**babcock & wilcox nuclear operations group**

June 6, 2012  
12-069

Subject: Revision to Chapter 5, *Nuclear Criticality Safety*, of License SNM-42 License Application

To	Licensing Administrator	File No. or Ref. - NCS-2011-186
From	William D. Newmyer, Nuclear Criticality Safety Engineer	Date December 7, 2011
Subj.	NCS Safety Analysis for LTC Indoor Storage Tubes Fixed Spacing - CA200902133

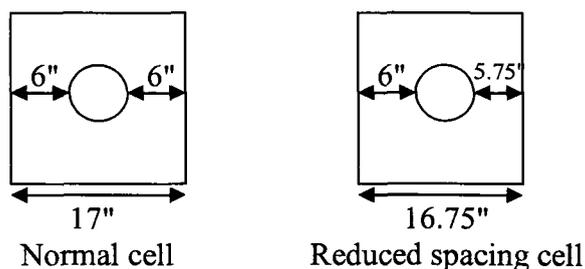
During the IROFS Verification Project for LTC documented in Reference 1, it was discovered that the spacing between two of the LTC storage tubes inside the CHA was less than the required 17" center-to-center resulting in less than 12" edge-to-edge separation. The actual separation distance between tubes 11 and 12 was 16.5". This analysis will show that a reduction in the edge-to-edge spacing from 12" to 11.5" has an insignificant effect on  $k_{eff}$ .

As described in Reference 1, the inspected storage tubes inside the CHA at LTC are 67 inches tall and 5 inches in diameter. A shield plug made of concrete sits inside the hole. The shield plug is 29 inches long. Therefore, the length of tube into which material may be stored is 38 inches. See the diagram below labeled as Figure 1.

Figure 1: Plot of reactivity versus low water density for <sup>235</sup>U storage tube (vertical error bars represent 2\*uncert value for each point)

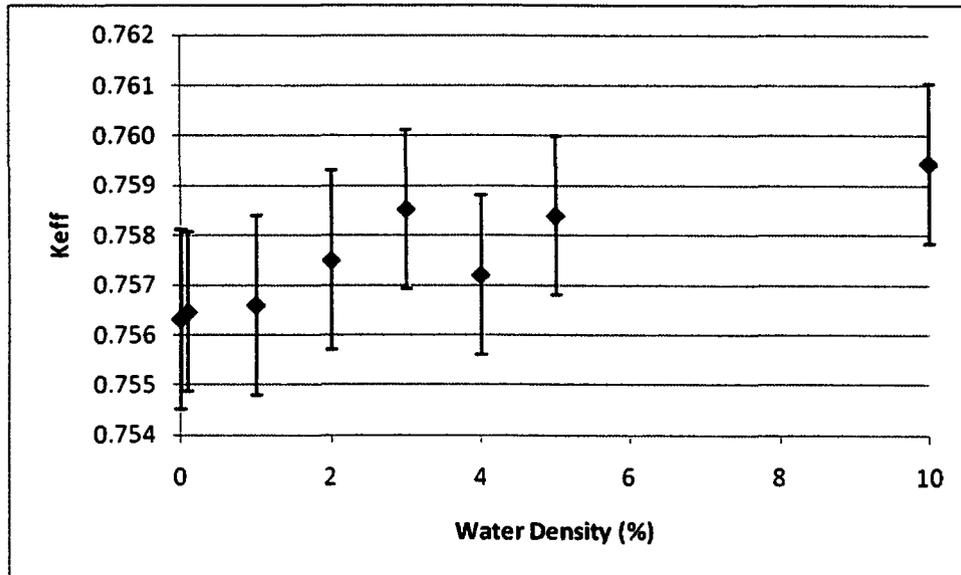
Calculations shown in Table 1 are summarized in Table 10 below. The results are plotted in Figure 1. The results show that there is no peak in reactivity at low water densities. The plot also shows that there is no statistical difference between the reactivity at 0% up to 10% water density. Therefore the arbitrary choice of 0.1% water for the low density cases is acceptable.
